**COMMUNITY DEVELOPMENT
DEPARTMENT REPORT**

APPLICANT: Elizabeth Allen
 SUBJECT: H-2024-0030
 Treasure Valley Law Enforcement
 Childcare

LOCATION: 1085 S. Ten Mile Rd., in the SW 1/4 of
 Section 15, T.3N., R.1W.

Conditional Use Permit to construct and operate a 7,504 square foot daycare center in the M-E zoning district, by Ball Ventures Ahlquist.

D. Landscape Plan (date: 6/14/2024)

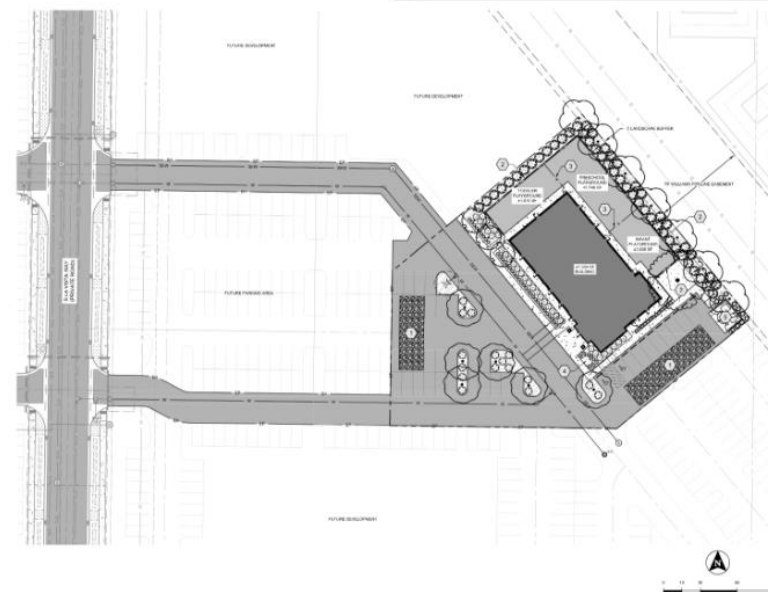
The applicant is required to add extra shrubs to all planter islands and plant one additional tree in the planter island with the fire hydrant (with a minimum of one tree per planter island). Requests for alternative compliance to this standard can be made as permitted under UDC 11-5B-5. Additionally, the applicant must remove two parking stalls from the southeast parking area adjacent to the trash enclosure to ensure sufficient ingress and egress. Lastly, the applicant should widen the planter island south of the trash enclosure to 5 feet (measured from inside of the curb) and meet the minimum requirement of 50 square feet.

A loading zone is currently proposed along the front of the building without any stripping. The applicant shall stripe the loading zone as parallel parking (9' x 23') and install a planter island with a bulb out on the north portion of the loading zone to match the southern portion.

3. The site plan and/or landscape plan, as applicable, shall be revised with the certificate of zoning compliance application as follows:
 - i. Depict a minimum 5-foot wide pedestrian walkways from the perimeter sidewalk (along La Vista Lane and Williams Pipeline pathway) as shown on the concept plan; the walkways shall be distinguished from the vehicular driving surfaces through the use of pavers, colored or scored concrete, or bricks as set forth in UDC 11-3A-19B.4.

- ii. Additional shrubs and an additional tree are required in the planter island with the fire-hydrant (a minimum of 1 tree is required per planter island); alternative compliance to this standard may be requested as allowed in UDC 11-5B-5. Planter islands shall be a minimum of 50 square feet and dimensioned with future submittals.

- iii. Include shrubs and lawn or vegetative groundcover along with the trees within the landscape strips along the multi-use pathway within the street buffer along the eastern boundary of the site adjacent to the William pipeline in accord with the standards listed in UDC 11-3B-12C.

- iv. Provide a fencing detail in accord with the standards listed in UDC 11-4-3-9.
 - v. Stripe the loading zone as parallel parking (9' by 23') and install a planter island with a bulb out to match the southern portion of the loading zone.

- vi. Remove the two parking stalls to the north of the trash enclosure to provide an adequate ingress/egress.
 - vii. Widen the planter island south of the trash enclosure to 5 feet in accord with UDC 11-3B-8.

- viii. Provide additional parking further west designated as future parking on the concept plan to provide for adequate ingress and egress for employees, customers, and republic service.

E. Building Elevations (date: 6/14/2024)

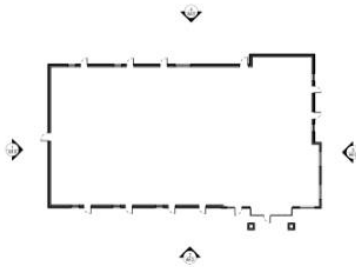
The proposed elevations align with the Architectural Standards Manual and TMISAP guidelines. The applicant must apply for an administrative design review following the completion of the Conditional Use Permit (CUP) process. **However, the District has**

4. The design of the proposed structures shall comply with the design standards in the Architectural Standards Manual and the design elements in the Ten Mile Interchange Specific Area Plan (TMISAP) as noted in the Application of the Design Elements table on pg. 3-49 for the Mixed Employment (ME) designation, unless otherwise modified in the Development Agreement (DA).
